Probabilistic Risk Assessment Input to Decommissioning Requirements

NRC/Industry/Public Workshop

Risk-Informed Basis for Decommissioning Exemption Guidance

July 15-16, 1999

Figure 3.3-1 Comparison of Spent Fuel Time Line for Loss of Cooling Events

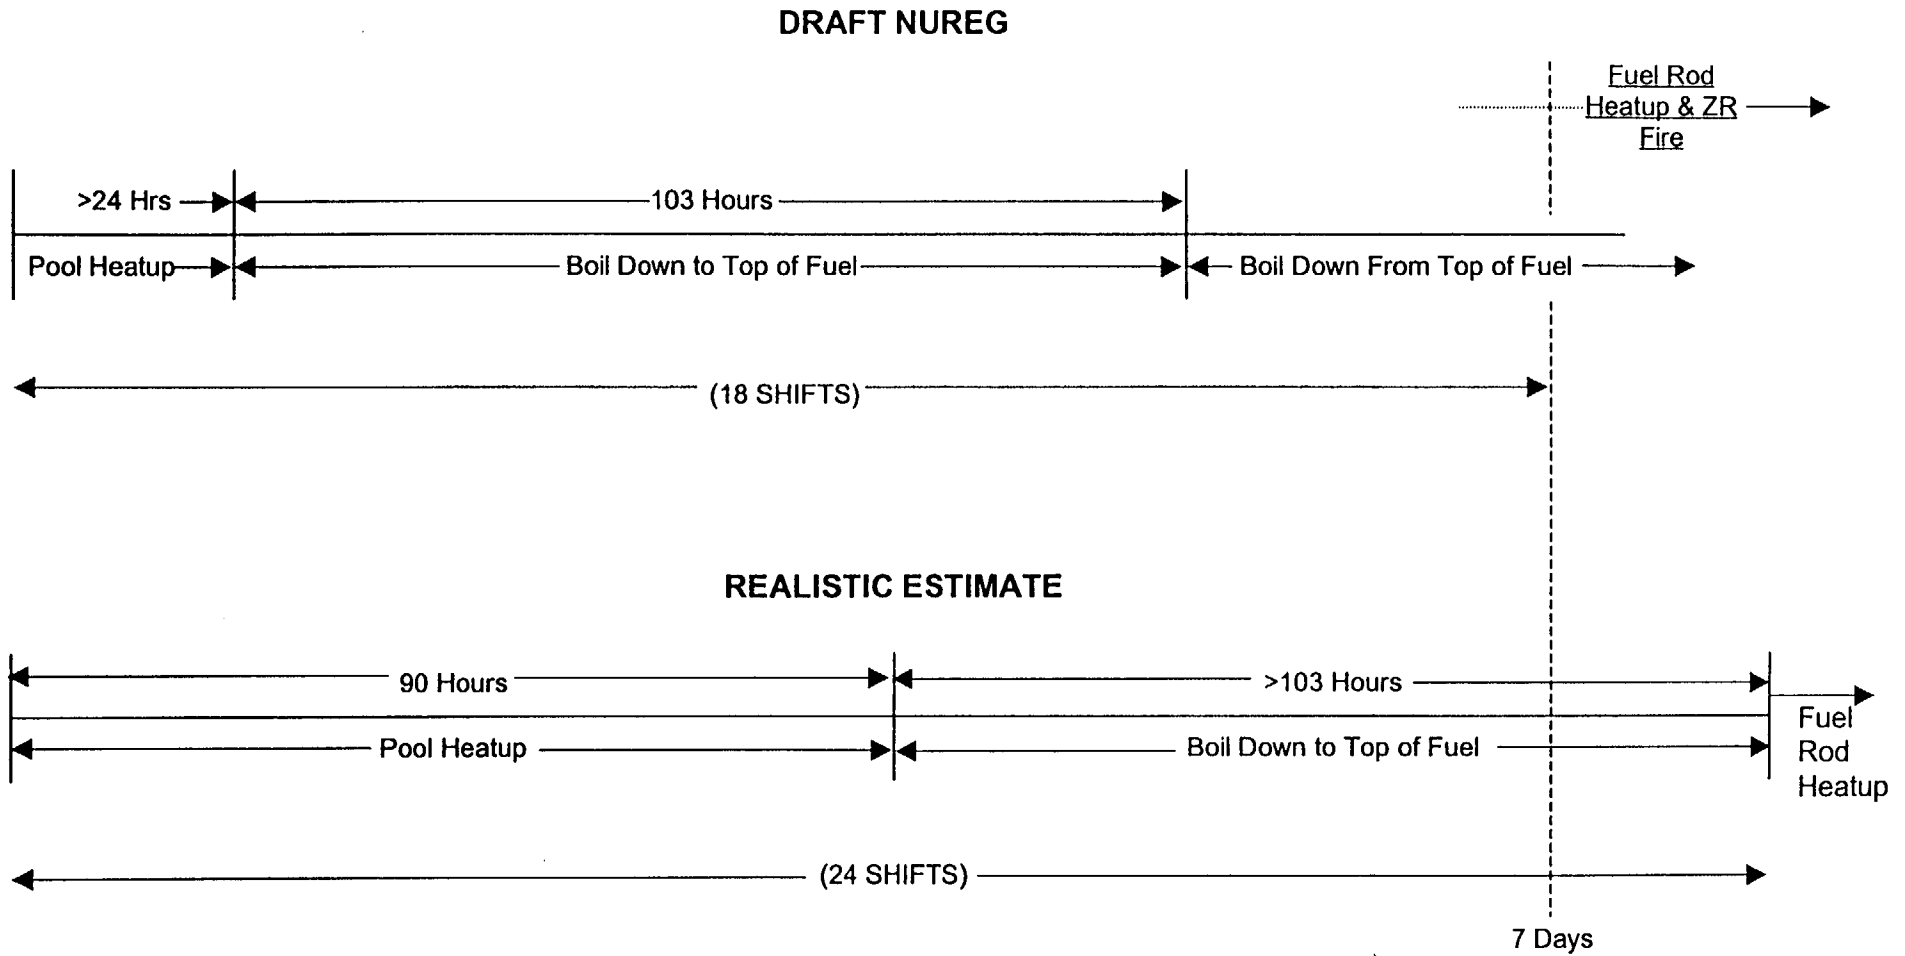
The two orders of magnitude change in perceived frequency appears to be strictly a conservative bias introduced

CONSERVATISMS

Table 2.1-1
KEY TEMPERATURES IN THE ASSESSMENT OF
ZIRCONIUM IGNITION & RUNAWAY OXIDATION

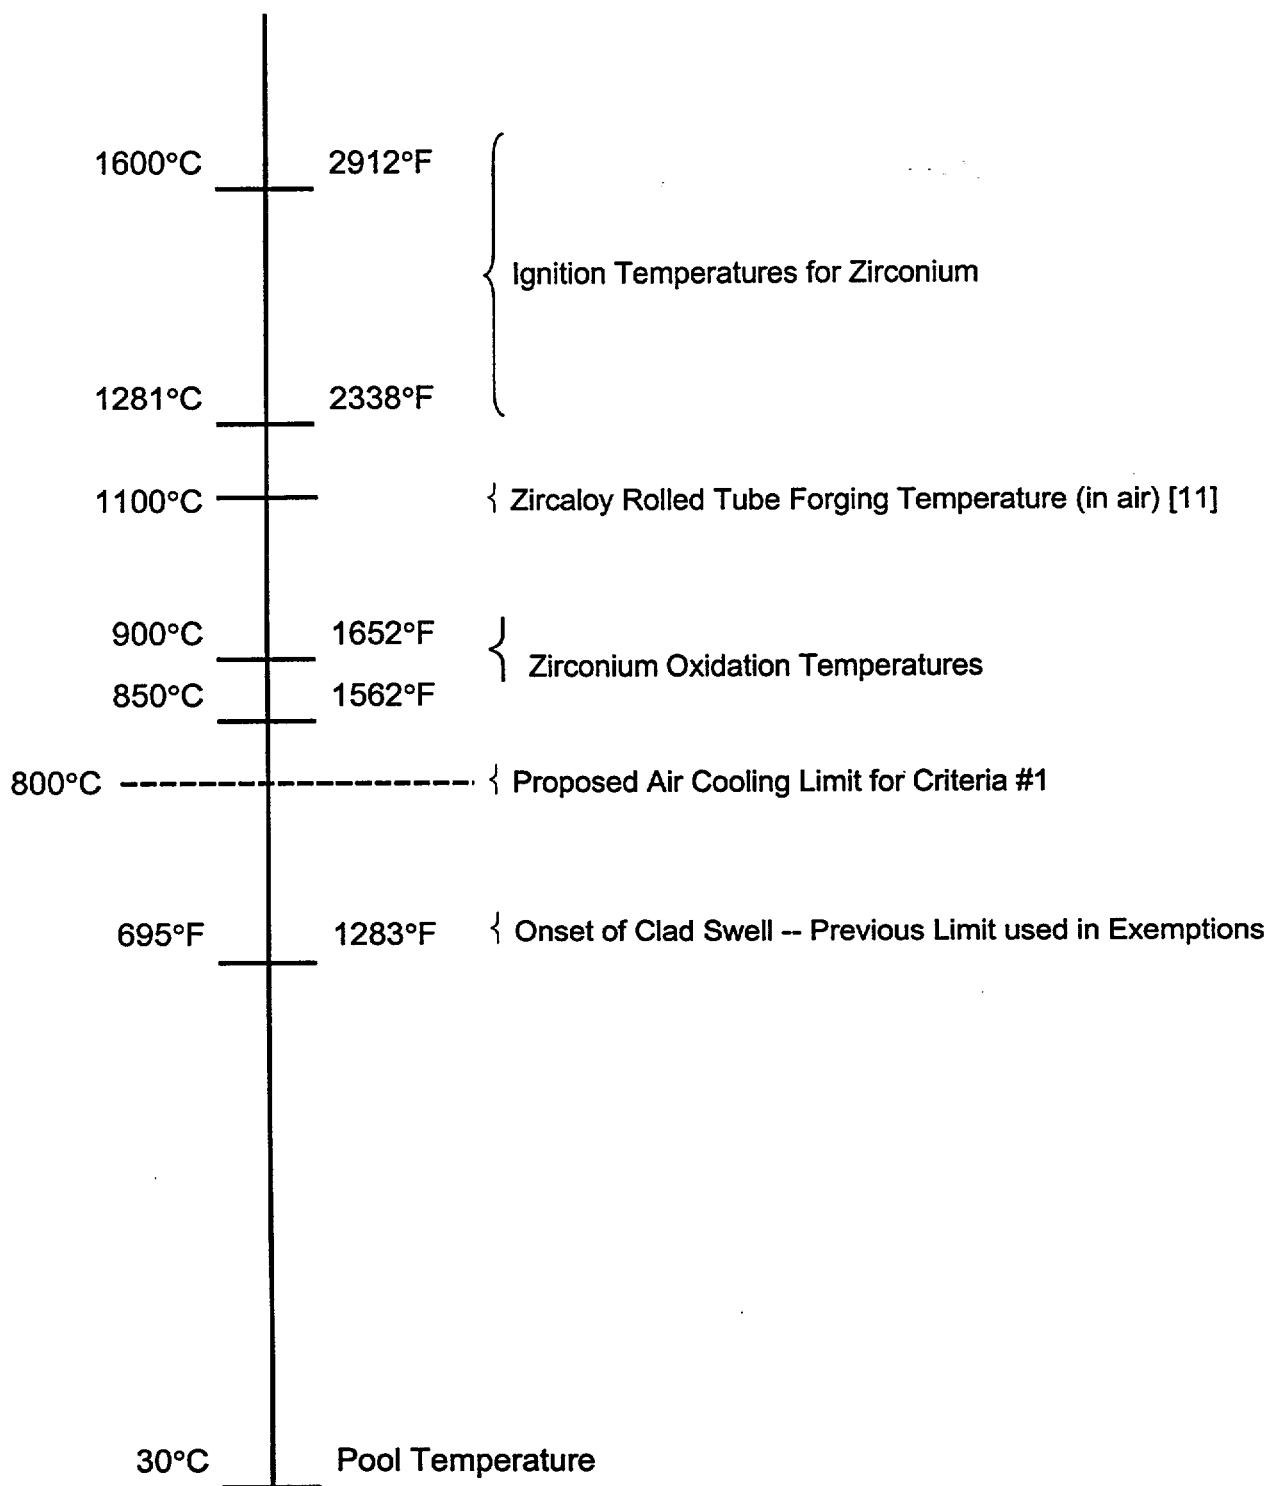
Ignition Temperature (Section 2.1.1)

“The oxidation temperature reported by SNL was the onset of oxidation, but not the temperature at which rapid, runaway oxidation or ignition occurs”

Nevertheless 800°C is used despite references indicating that Zircaloy ignition is >1600°C.

**DISTRIBUTION OF CONTRIBUTORS TO FREQUENCY OF FUEL UNCOVERY (FFU) FROM
DRAFT NUREG
(Case I Total FFU=1.2E-5/yr)**

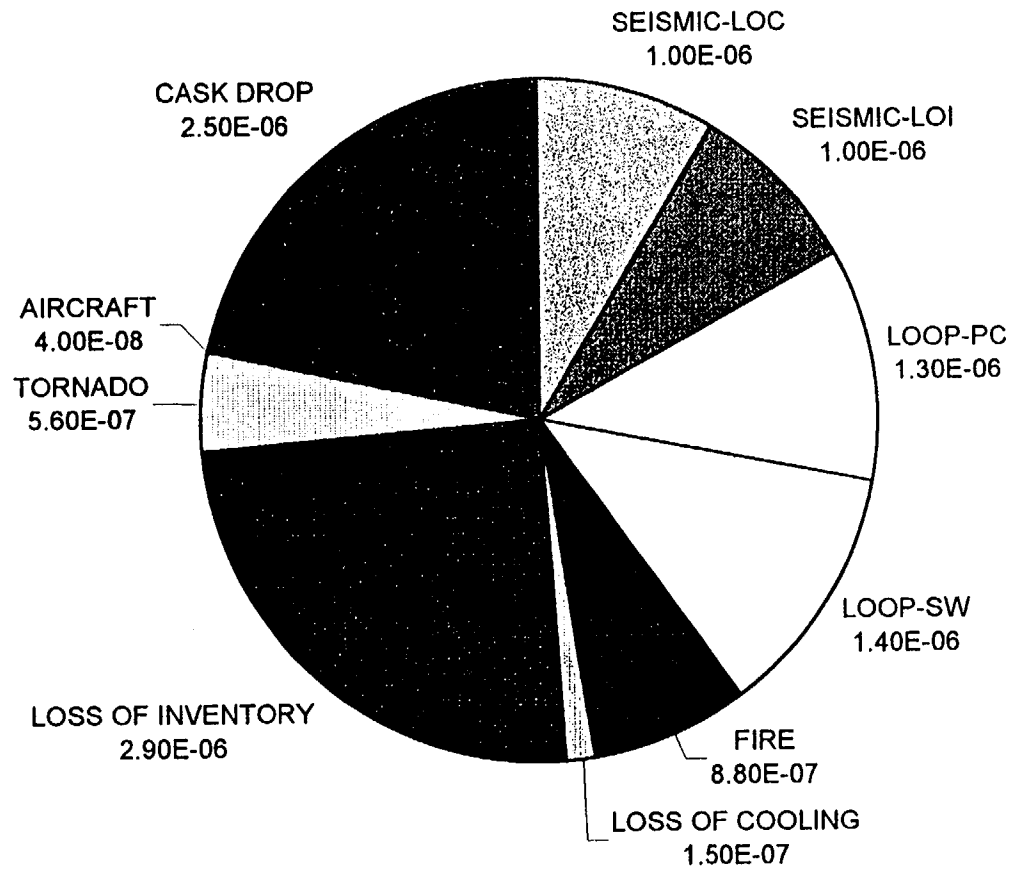
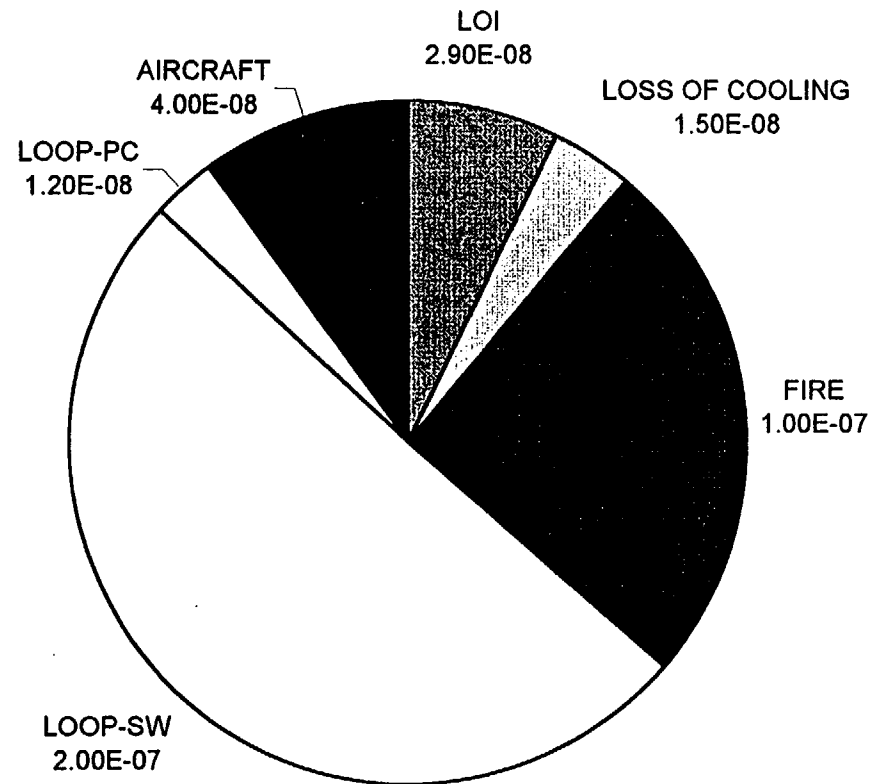
**DISTRIBUTION OF CONTRIBUTORS TO FREQUENCY OF FUEL UNCOVERY (FFU) FROM
BEST ESTIMATE CALCULATION
(Case I Total FFU=4E-7/yr)**

- # An approximate requantification demonstrates substantial conservatism in NRC risk estimates
- # Perform requantification of the risk analysis to reflect
 - Past NRC analysis
 - Current PRA HRA practice
 - Best estimate analysis -- not “worst case”
